**ADDENDUM NO. 01**  
**July 9, 2018**

To Drawings and Specifications dated June 25, 2018

**Santa Fe Independent School District**  
**2018 FALL REROOFING PACKAGE**

PBK Project No.: 1879  
Notice to Proposers

SANTA FE INDEPENDENT SCHOOL DISTRICT  
PROJECT NUMBER 1879  
DATE JUNE 25, 2018  
DRAWN BY  
CHECKED BY  
**ISSUE FOR PROPOSAL**  
**A1**  
E.Y. COWEN EDUCATION CENTER ROOF PLAN

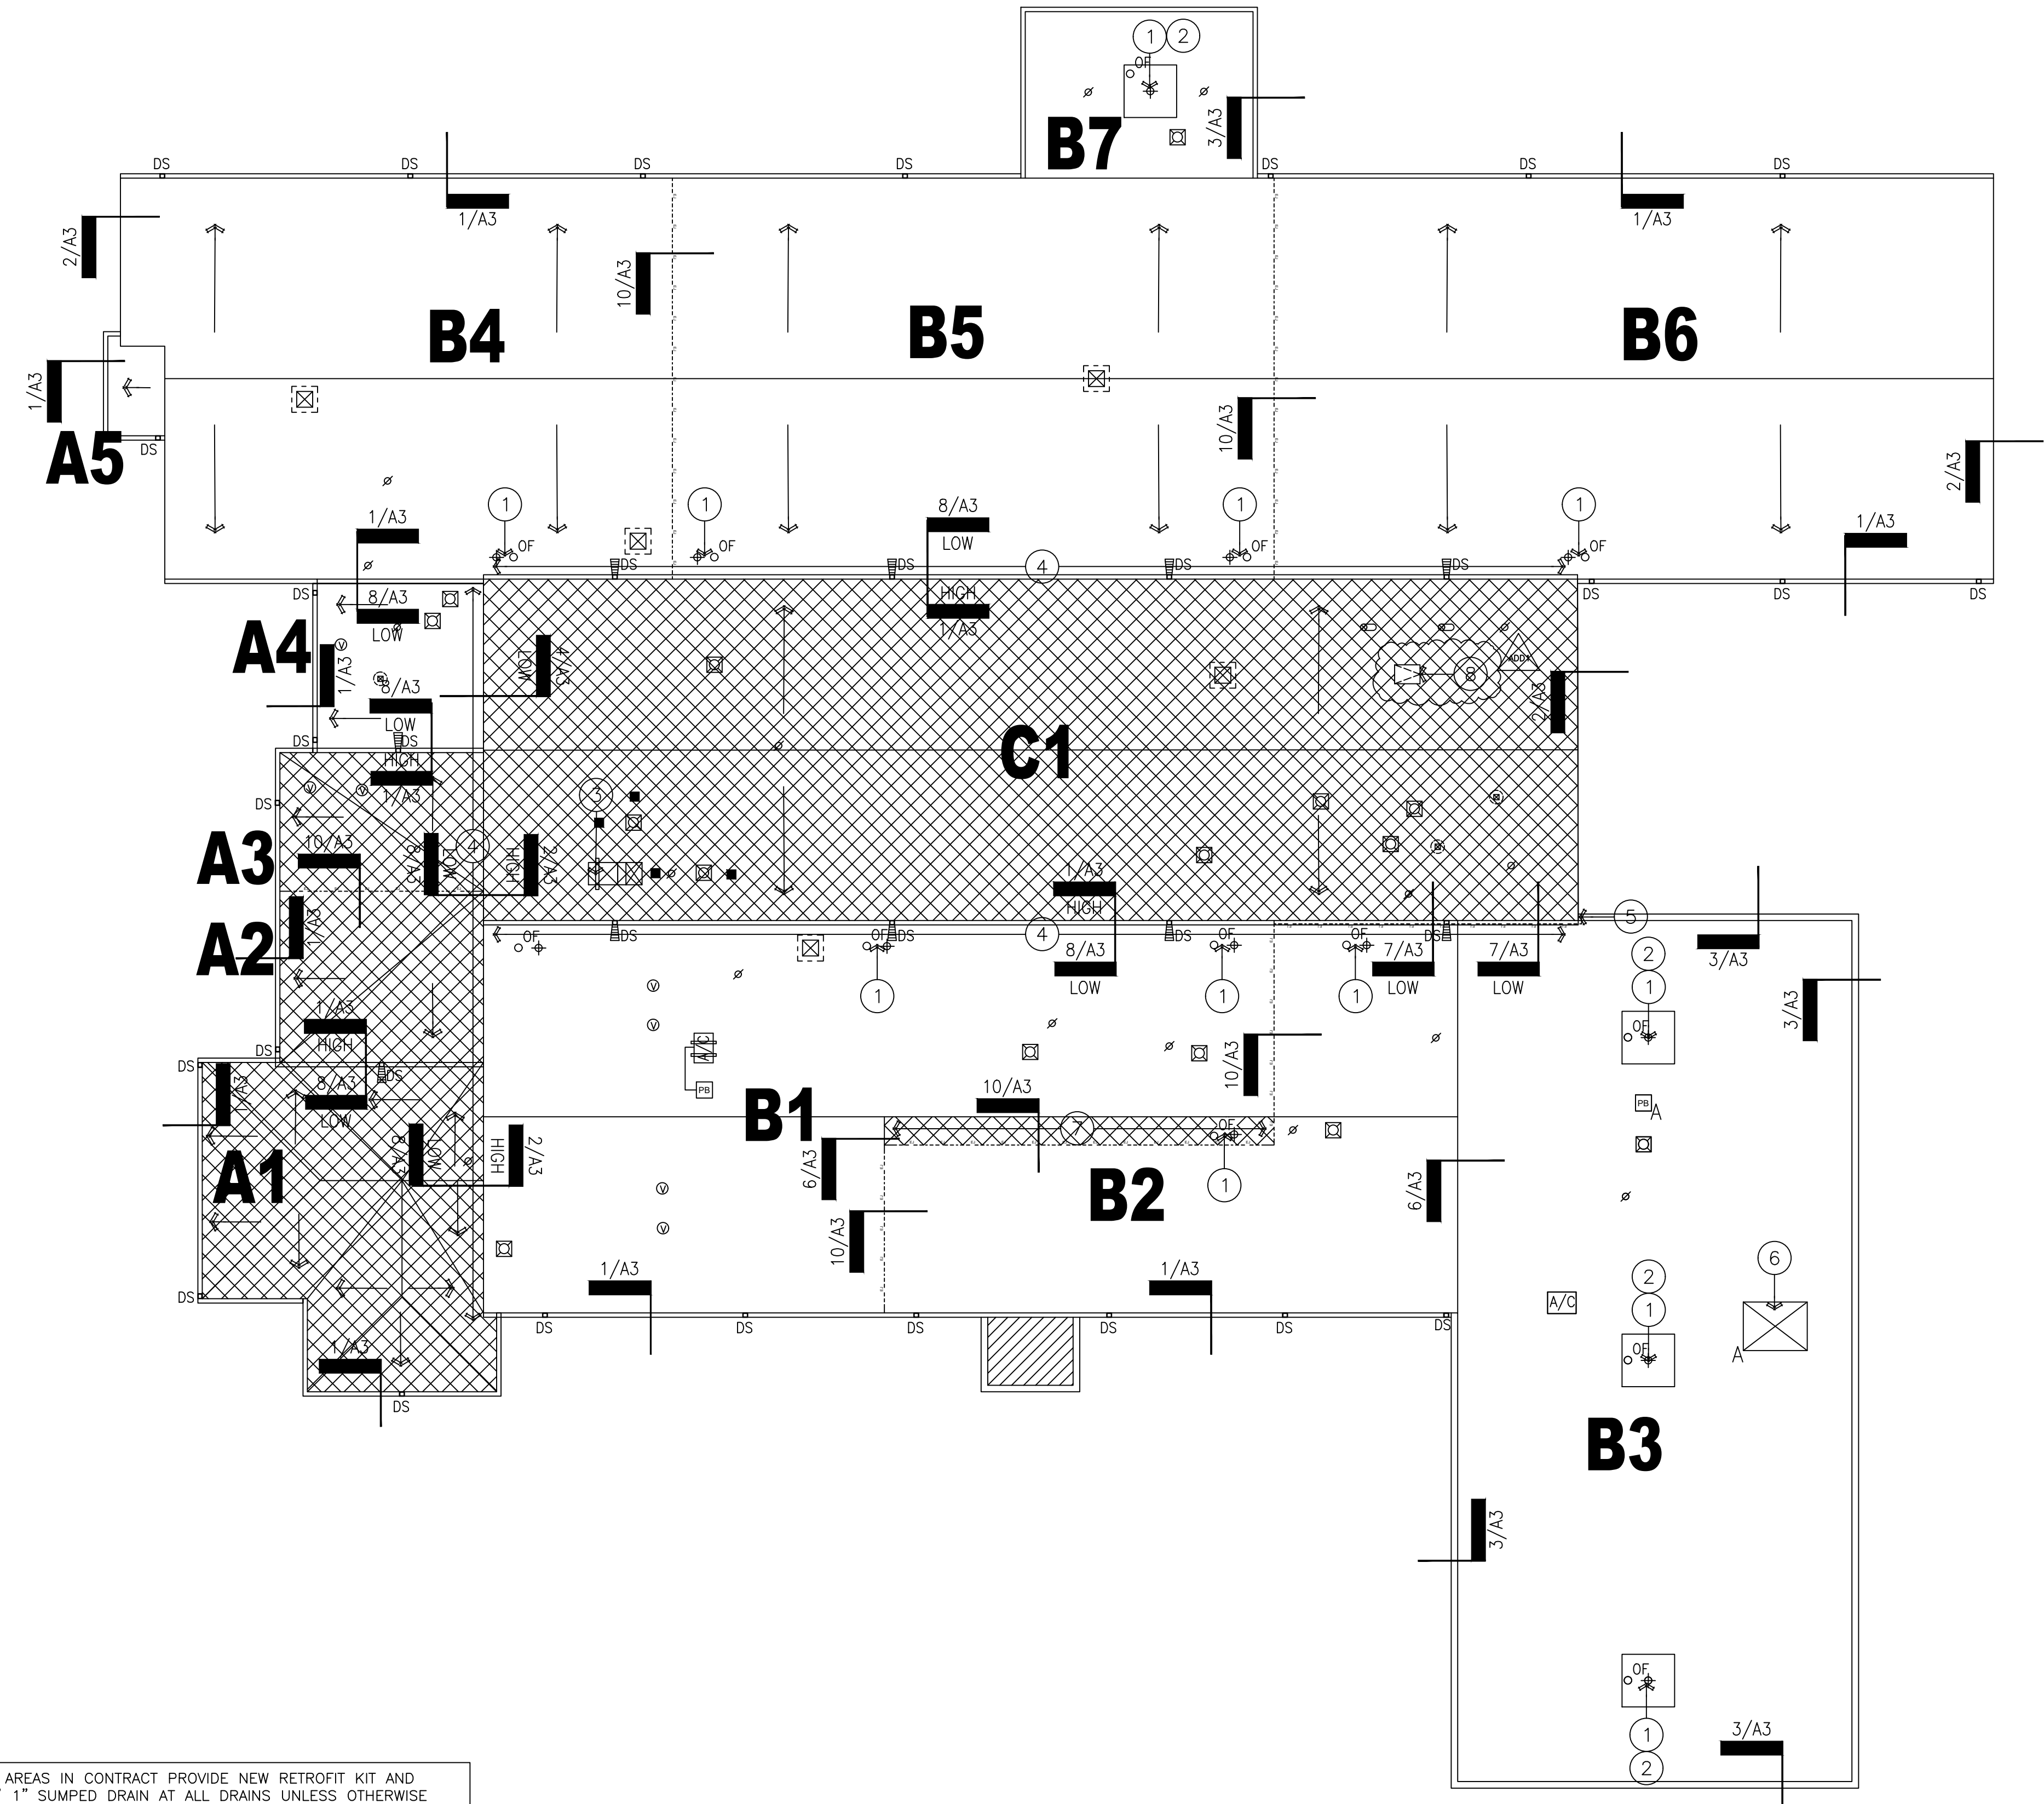
- Item No. 09 A1-E.Y.Cowen Education Center Roof Plan: Add Keyed Note No.8 to read "NEW ROOF ACCESS HATCH AND LADDER. MOUNT LADDER TO SLAB AND MODIFY EXISTING ELECTRICAL TO ACCOMMODATE NEW OPENING. REMOVE EXISTING METAL DECK, INSTALL 3X3 ANGLES AND ATTACH WOOD BLOCKING TO HIEGHT OF NEW ROOF ELEVATION". Keyed Note No.8 placed on Roof Section C1. See attached Sheet A1.
- Item No. 10 A2-Santa Fe Junior High Roof Plan: Remove Keyed Note No.2. See attached Sheet A2.
- Item No. 11 A2-Santa Fe Junior High Roof Plan: Change Keyed Note 7 at Roof Section C1 to 11. See attached Sheet A2.
- Item No. 12 A2-Santa Fe Junior High Roof Plan: Added Keyed Note 17 to Roof Section B4. And modified note to include conductor head and splash pan. See attached Sheet A2.

- 7 PROVIDE TAPERED INSULATION TO SLOPE ROOF TO PLAN NORTH.
- 8 NEW ROOF ACCESS HATCH AND LADDER. MOUNT LADDER TO SLAB AND MODIFY EXISTING ELECTRICAL TO ACCOMMODATE NEW OPENING. REMOVE EXISTING METAL DECK, INSTALL 3X3 ANGLES AND ATTACH WOOD BLOCKING TO HEIGHT OF NEW ROOF ELEVATION.
